SITE PLAN
HOMESTEAD, PHASE 1
LOT 9, BLOCK F
~AMENITY CENTER~

SP2023-046: Site Plan for Amenity Center within Homestead

PROJECT NUMBER: SP2023-046
PROJECT NAME: Site Plan for Phase 1, Homestead Subdivision
SITE ADDRESS/LOCATIONS: 3200 FISHER RD, ROCKWALL, 75032

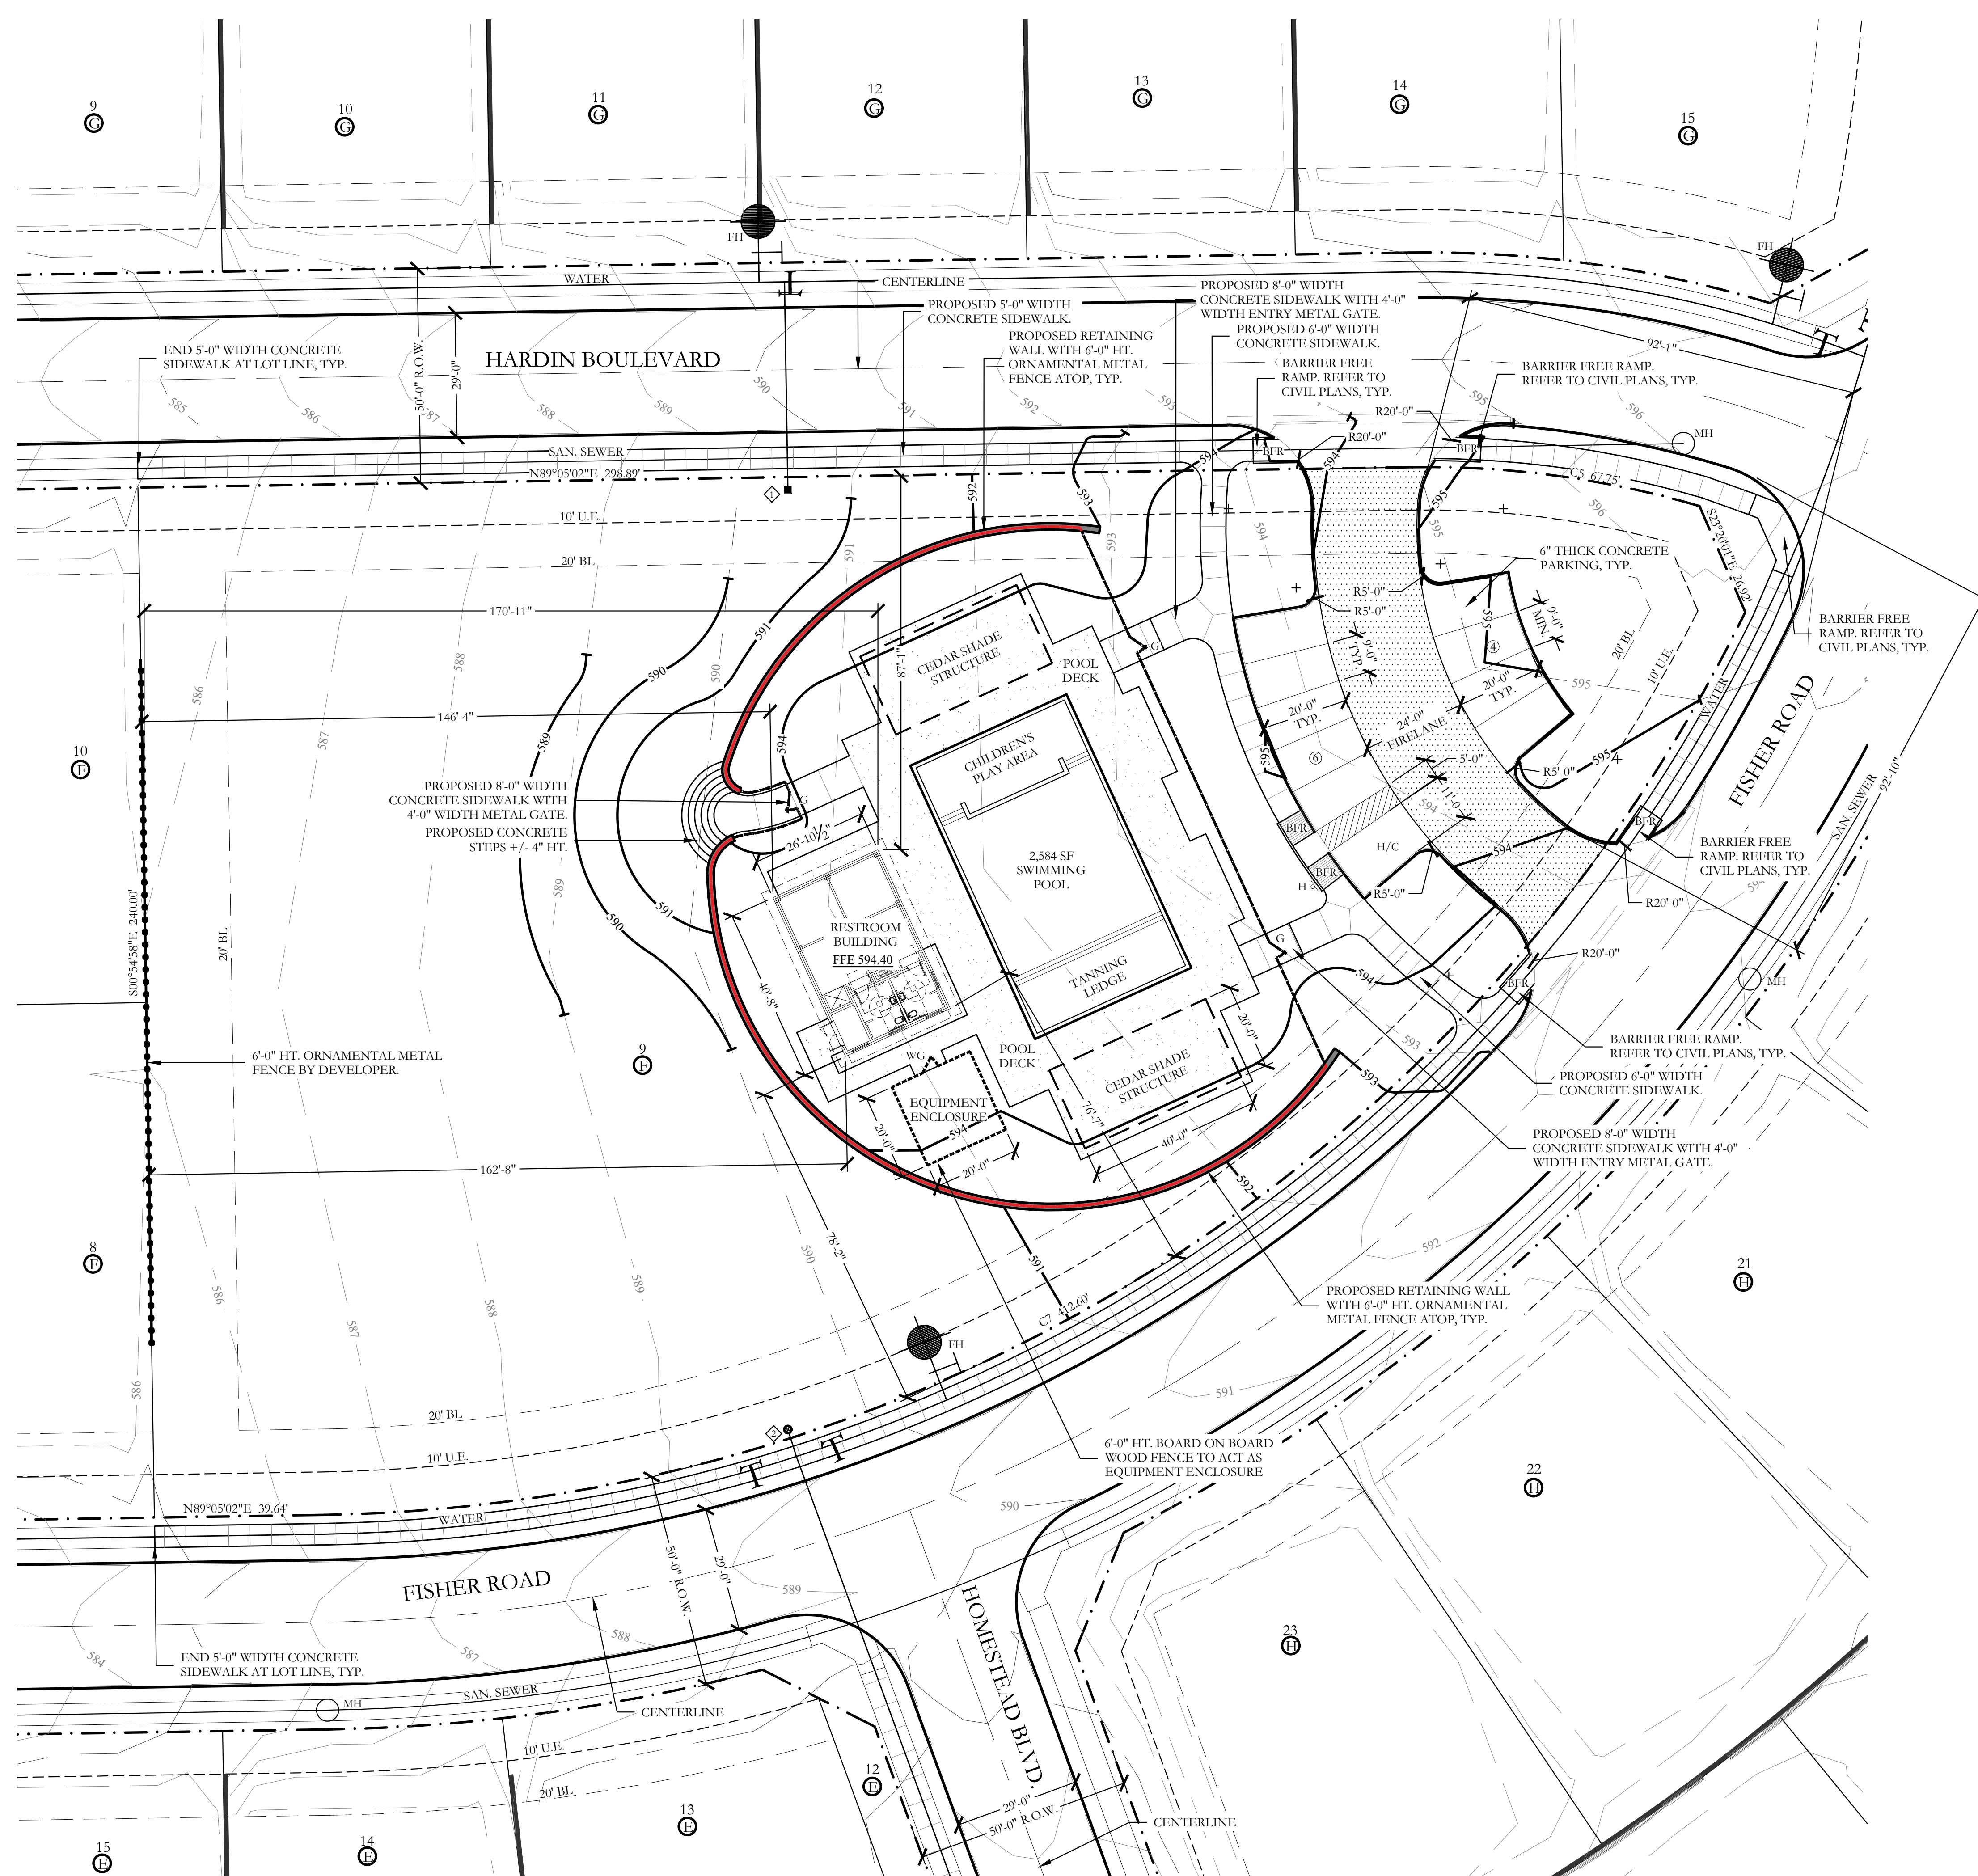
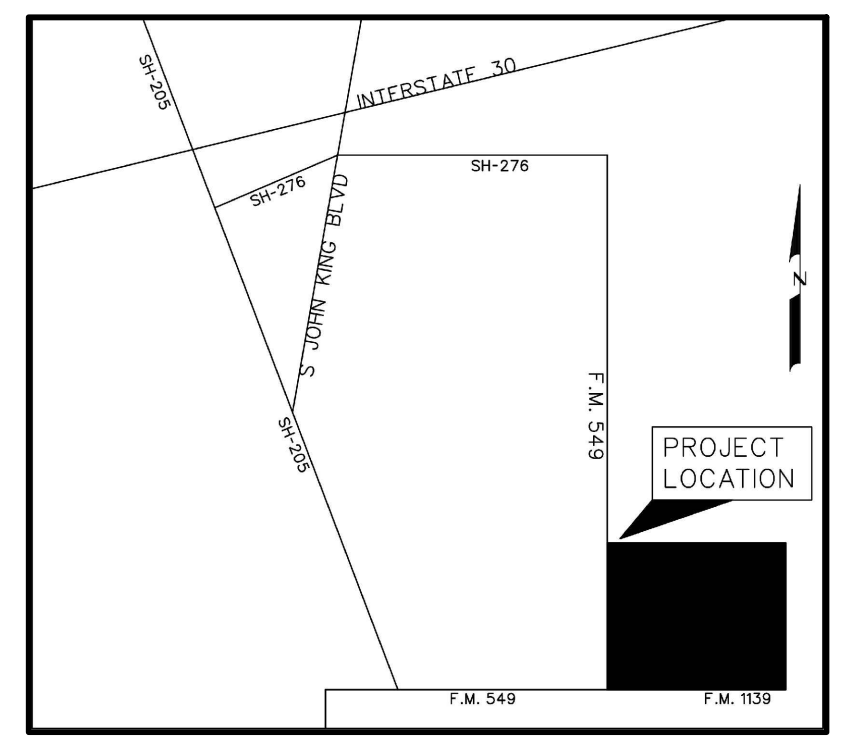
M.5 Site Plan:

(1) Wood fencing is not permitted as for the pool utility screening. That being said, horizontal composite board fencing has been approved previously. (Planned Development District 92)

(2) Please provide fence exhibits for each fence type. (Planned Development District 92)

(3) Please provide exhibits of the shade structures. (Planned Development District 92)

2. Please show proposed water and sewer house connections on site plan for this building.
3. Retaining walls over 3' in height will need to be engineered and a retaining wall permit application shall be submitted to the engineering department for review.
4. Label as rock or stone retaining wall.
5. Make sure landscaping doesn't impede drainage and can't fill in swale.
6. Edging must be higher than mulch to contain.

**SITE PLAN
HOMESTEAD, PHASE 1
LOT 9, BLOCK F
~AMENITY CENTER~**

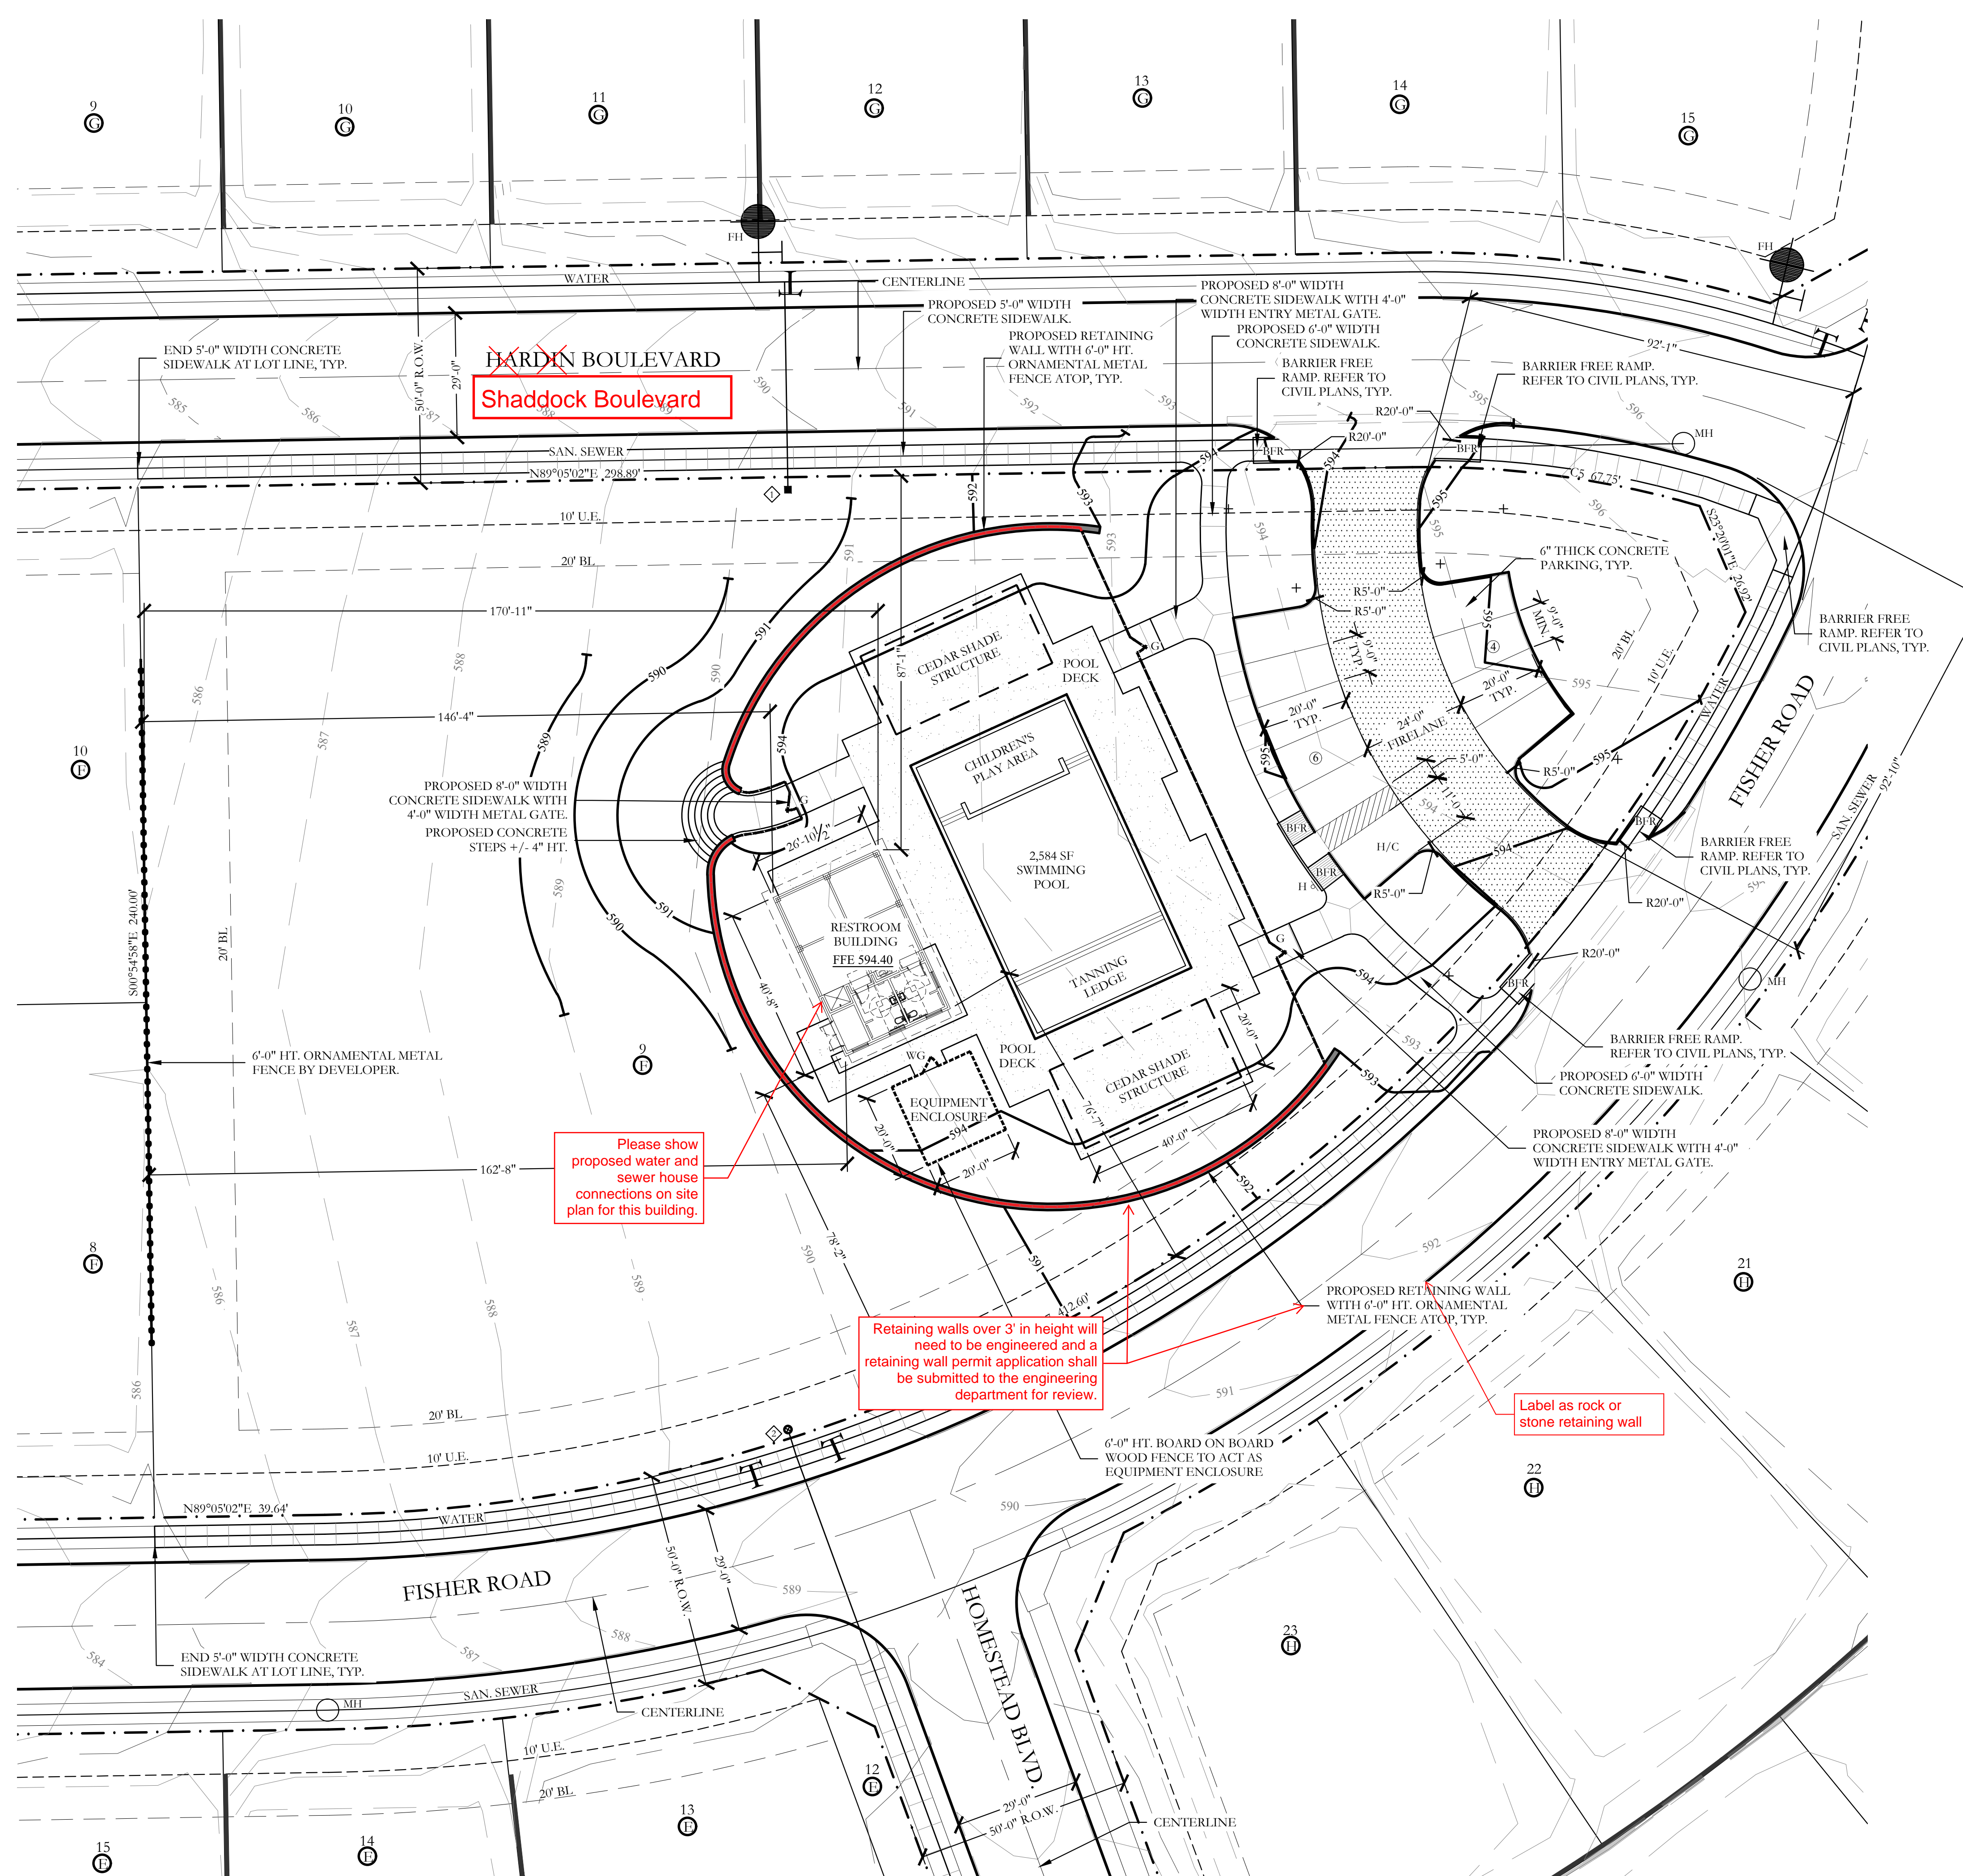
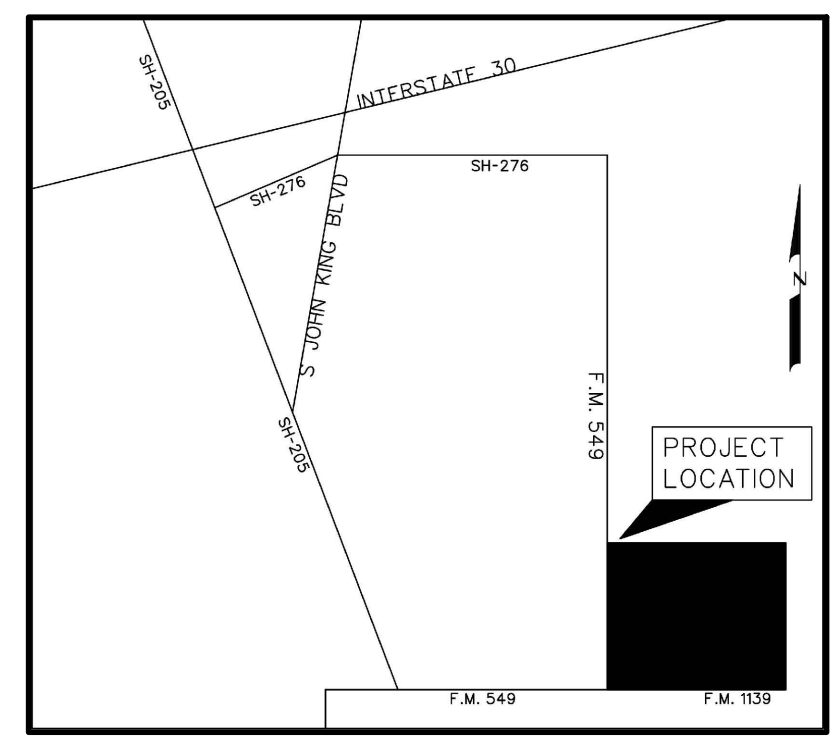
11/14/2023: 1. Very nice looking landscape
2. Suggestion of replacing the Common Bermuda Sod which one of the newer varieties such as Tif Tuf, Tahoma 31, Northbridge, Latitude 36 of which all are more cold, drought, wear tolerant.

- General Items:**
- Must meet City's 2023 Standards of Design and Construction
 - 4% Engineering Inspection Fees
 - Impact Fees (Water, Wastewater & Roadway)
 - Minimum easement width is 20' for new easements. No structures including walls allowed in easements.
 - Retaining walls 3' and over must be engineered.
 - All retaining walls (18" or taller) must be rock, stone, or stone face. No smooth concrete walls.
 - All utilities must be underground.
 - Need to show proposed water and sewer on site plan.

- Water and Wastewater Items:**
- Only one "use" off a dead-end line (domestic, irrigation, fire sprinkler, fire hydrant, etc.)
 - Water and sewer must be 10' apart.
 - Sanitary sewer service must be connected to a manhole.

- Roadway Paving Items:**
- All Parking to be 20'x9' minimum.
 - No dead-end parking allowed without an City approved turnaround.
 - Drive isles to be 24' wide.
 - Fire lane to have 20' min radius if buildings are less than 30' tall. If any of the buildings are 30' or more, the fire lane will be 30' radius minimum.
 - Fire lane to be in a platted easement.

- Landscaping:**
- No trees to be with 10' of any public water, sewer or storm line that is 10" in diameter or larger.
 - No trees to be with 5' of any public water, sewer, or storm line that is less than 10".

Please show proposed water and sewer house connections on site plan for this building.
